Proposed Milton Quarry East Extension JART COMMENT SUMMARY TABLE – Natural Environment

JART Comments (December 2022)	Reference	Source of Comment	Applicant Response (Jan 2023)	JART Response
Repoi	rt/Date: Level 1 and 2 Natural Environment Technical Report (NETR) and Environ	mental Impact Asses	ssment (EIA) Dec	ember 2021 Author: Goodban Ecological Consulting	Inc. (GEC)

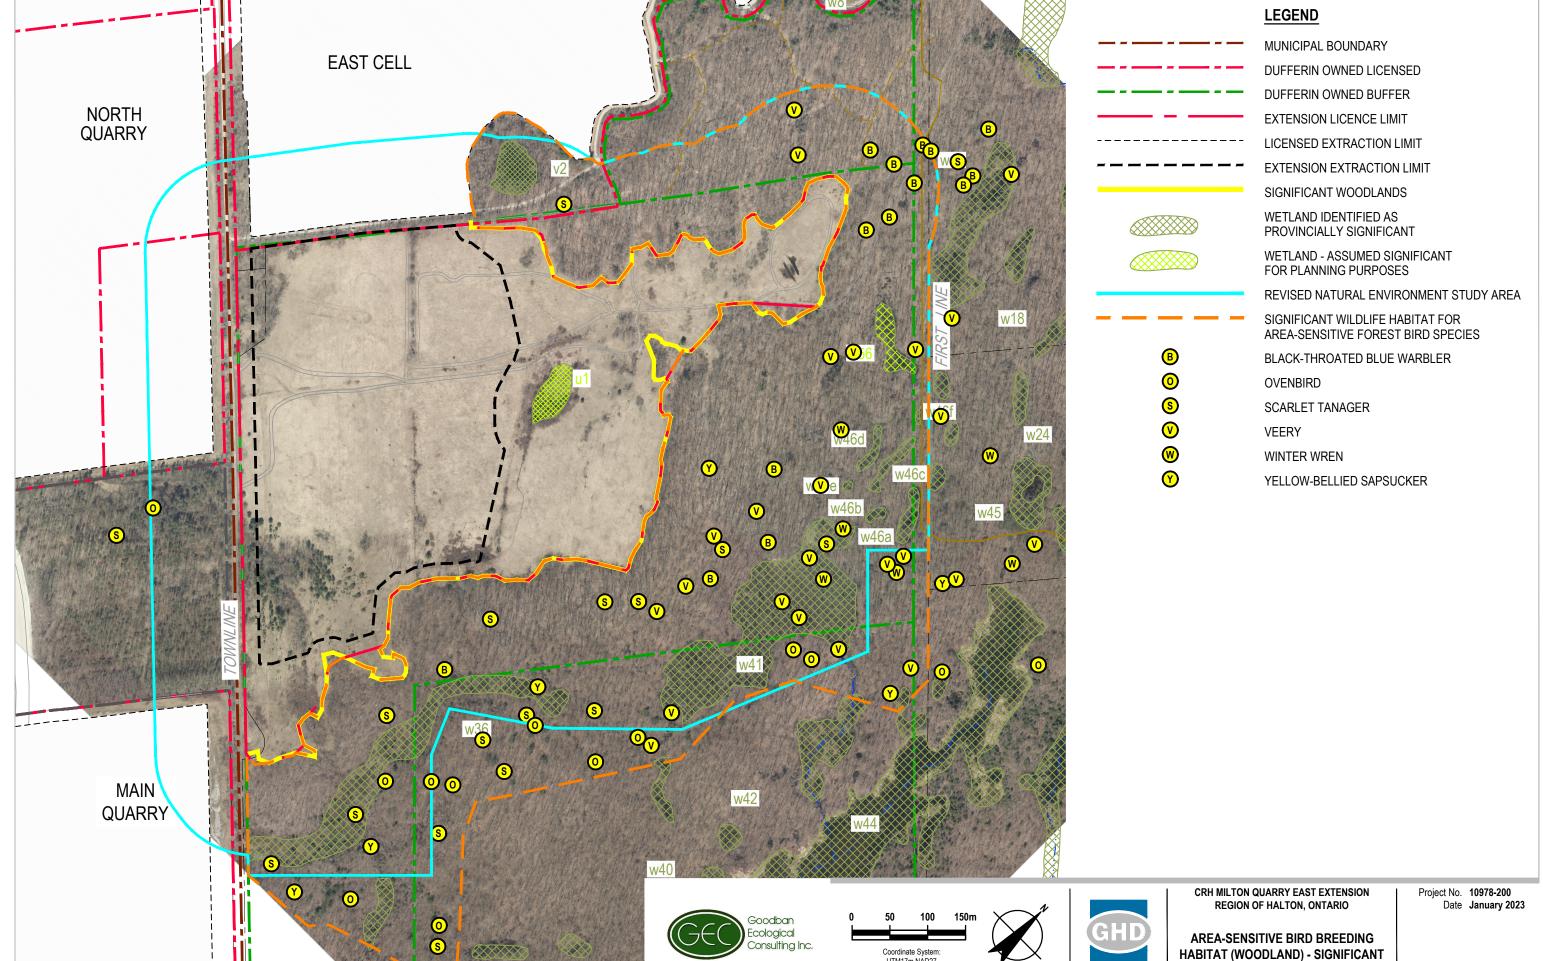
34.	The Level 1 and 2 NETR and EIA (Goodban 2021b) identified a confirmed Jefferson Salamander and Unisexual Ambystoma breeding pond contained within the licensed area of the MQEE named as wetland U1. The NETR also identified another confirmed Jefferson Salamander and Unisexual Ambystoma breeding pond breeding pond, known as wetland V2, that occurs just outside of the licensed area boundary to the north and northeast of the proposed extraction area limit.		Matrix Solutions	This comment does not provide a specific question, only statements and assumptions. Tab D Figure 1 illustrates the buffers and setbacks associated with Wetland V2 which is located within the existing East Cell licence area. Extraction has already occurred in proximity to Wetland V2 and is completed. No evidence of blasting-related effects upon amphibians was observed during routine ecological and water resources monitoring at V2. A 50 m buffer is proposed for Wetland U1, as shown on numerous figures and described in detail in the NETR & EIA. Blasting will not "occur within 50 m of Wetland U1". The limit of extraction-related disturbance is set at 50 m from Wetland U1. A stable 2:1 slope must be established between the ground surface and top of bedrock from that limit, so any blasting will occur at a distance greater than 50 m from Wetland U1. Please also refer to Dufferin's responses provided in the separate JART Comment Summary Table – Blast Impact Analysis (BIA).

WILDLIFE HABITAT FIGURE 31

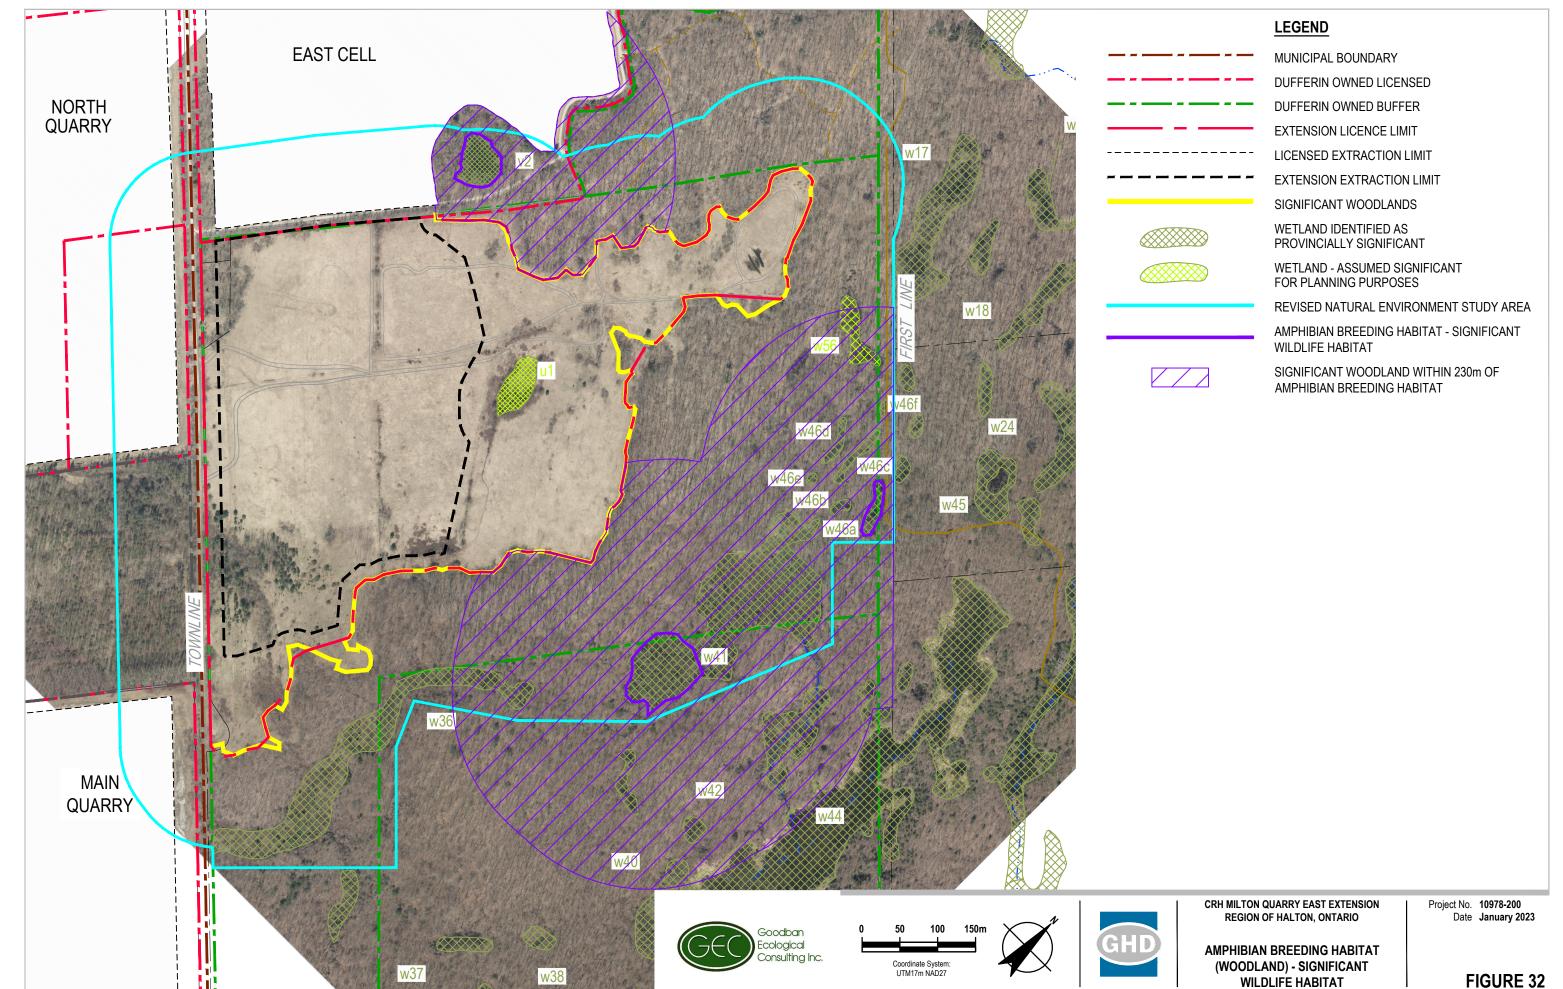
13.	Page 92 provides a description of Significant Wildlife Habitat (SWH) for breeding amphibians, which is supported by mapping in Figure 32. The Ecoregion Schedules for Ecoregion 7E specify that SWH for woodland breeding amphibians should include the breeding pool plus the woodland 230 m surrounding the pool. The SWH should be mapped accordingly.	Page 92	Sarah Mainguy, NSE	Please note that the MQEE is located in Ecoregion 6E. In Dufferin's July 22, 2022, responses to agency objection letters, NETR Figures 32 and 35 have been updated to map all woodland habitat within 230 m of the vernal pool habitats within Wetlands V2, W41 and W46a as SWH for Amphibian Breeding Habitat (Woodland). The updated NETR & EIA figures and updated ARA Site Plan detail showing Key Natural Heritage Features were provided to the agencies at that time. For ease of reference, the revised NETR Figures 32 and 35 are provided again at Tab A . The current draft ARA Site Plans are provided at Tab B .

See Tab A (Updated NETR & EIA Figures 31, 32, 34 and 35) and Tab B (Updated ARA Site Plans).	
			As indicated on page 75 of the NETR & EIA, Wetland W56 is a small, minor feature with a short, ephemeral
